STAFF REPORT COMMUNITY DEVELOPMENT DEPARTMENT

SUBJECT: FP-2020-0015
Pine 43 No. 3

Final plat consisting of 112 buildable lots and 16 common lots on 12.45 acres of land in the R-15 zoning district for the third phase of Pine 43 Subdivision.

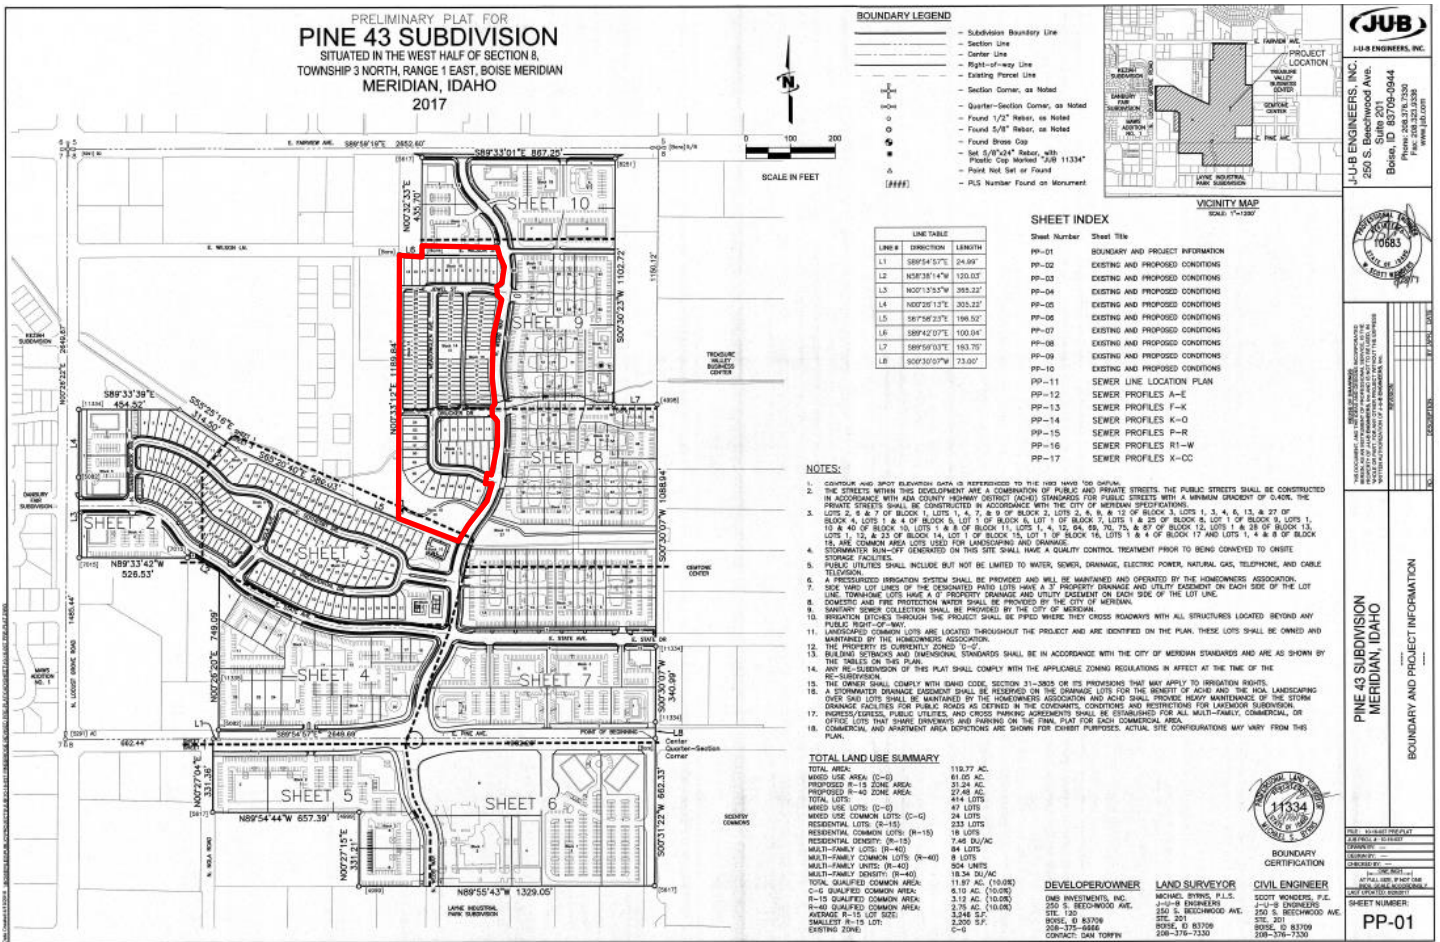
Some changes have been made to the configuration of lots within this phase of development resulting in six (6) *more* buildable lots than shown on the preliminary plat for this area and an increased amount of common open space. The Phase 1 final plat contained the same number of buildable lots and common area as depicted on the preliminary plat. The Phase 2 final plat contained six (6) fewer

lots and the same amount of common area as depicted on the preliminary plat. Overall, there is the same number of buildable lots and the amount of common open space area has increased from that approved with the preliminary plat between the first three phases; therefore, the proposed final plat is in substantial compliance with the approved preliminary plat as required.

The number of lots for single-family detached homes decreased from 38 to 19 and the number of lots for townhomes increased from 68 to 93. Staff is amenable to this change.

PLAT SHOWING
Pine 43 Subdivision No. 3

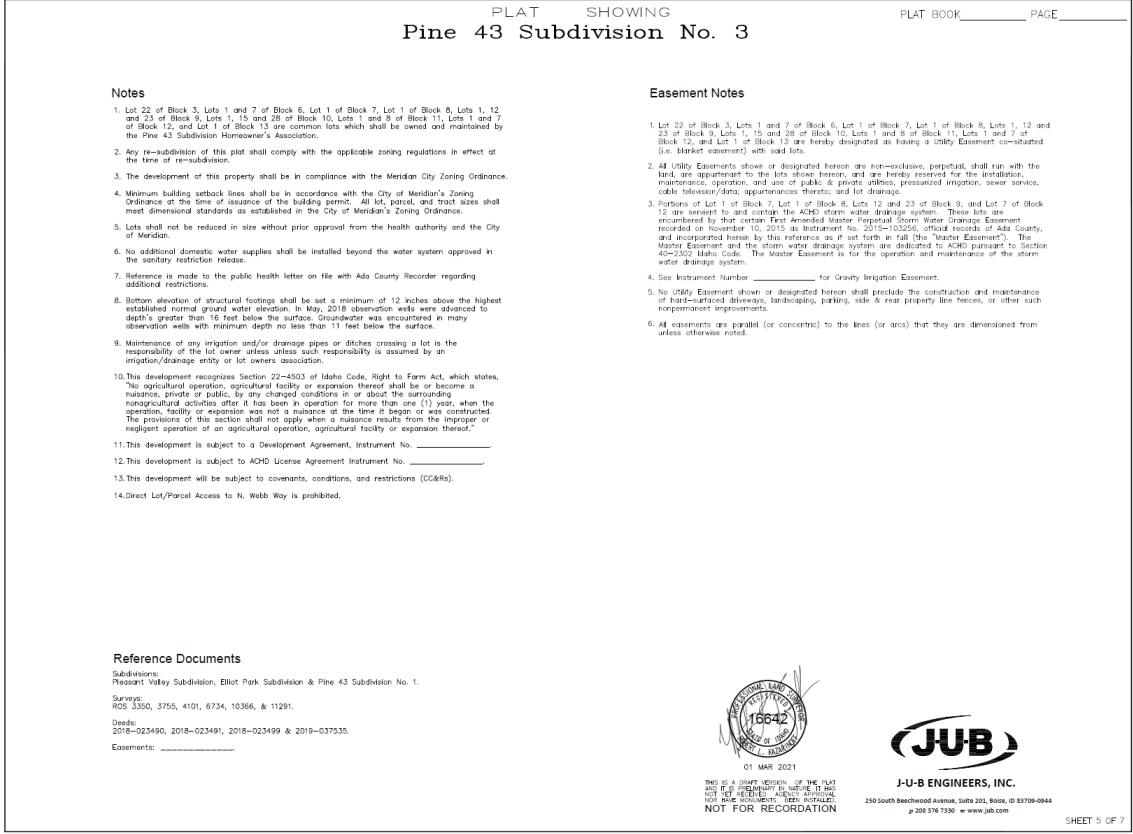
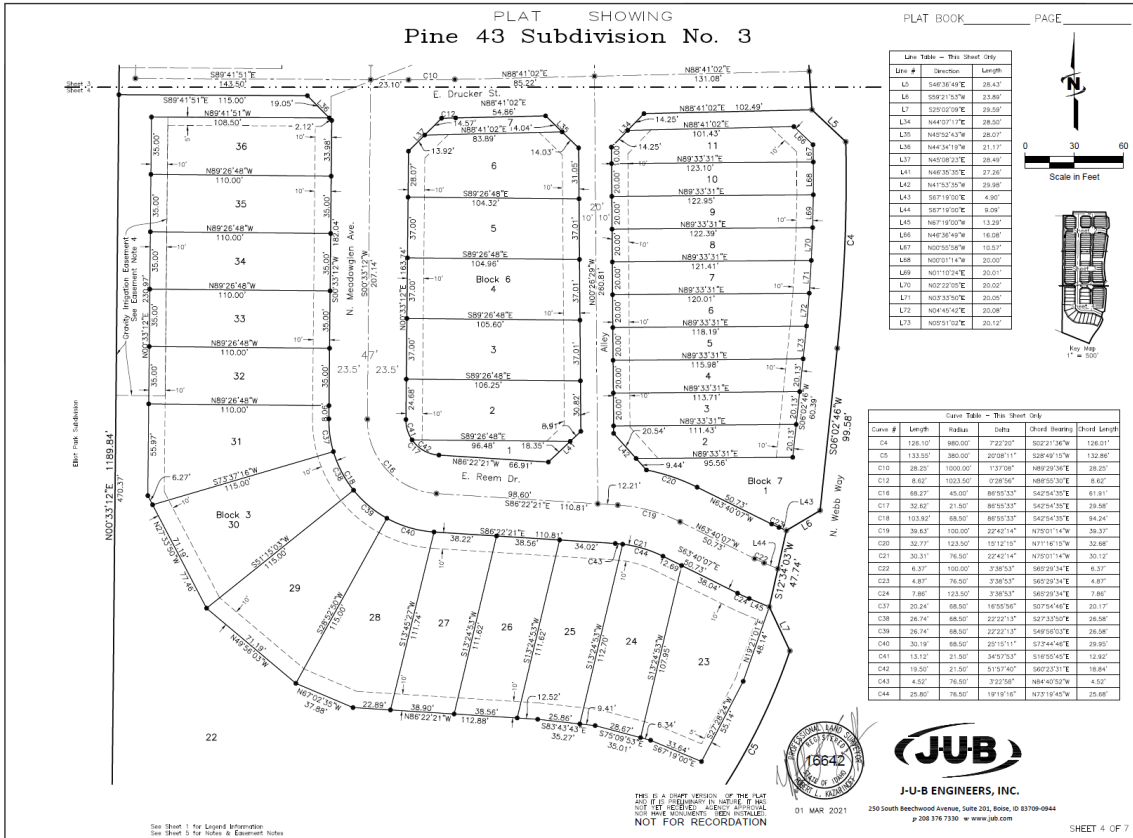
- a. Note #11: Include the recorded instrument number of the Development Agreement (#2018-000751).
- b. Note #12: Include the recorded instrument number of the ACHD License Agreement.

- c. Note #4: Include the recorded instrument number of the gravity irrigation easement.
- d. Note #5: Revise to read: "No Utility Easement shown or designated hereon shall preclude the construction and maintenance of hard-surfaced driveways or other similar hard surface flatwork, however permanent structures, trees, brush, or perennial shrubs or flowers within the area described for this easement shall be prohibited."

- e. Include the recorded instrument number for the Easements.

- f. Depict lot numbers on Lots 1 and 2, Block 11; Lots 1, 2, 27 and 28, Block 10; and Lot 22, Block 9.
- g. Extend E. Drucker Street and E. Jewel Street to the west property boundary so the alley that provides access to the lots in Block 16 complies with UDC 11-6C-3B.5e and is visible from a public street; or otherwise reconfigure this area to comply with UDC standards.
- h. An off-street parking area shall be provided for the alley accessed townhomes in Block 8 that front on W. Webb Way similar to that proposed in Blocks 6 and 10 on the preliminary plat.

A copy of the revised plat shall be submitted for City Engineer signature.
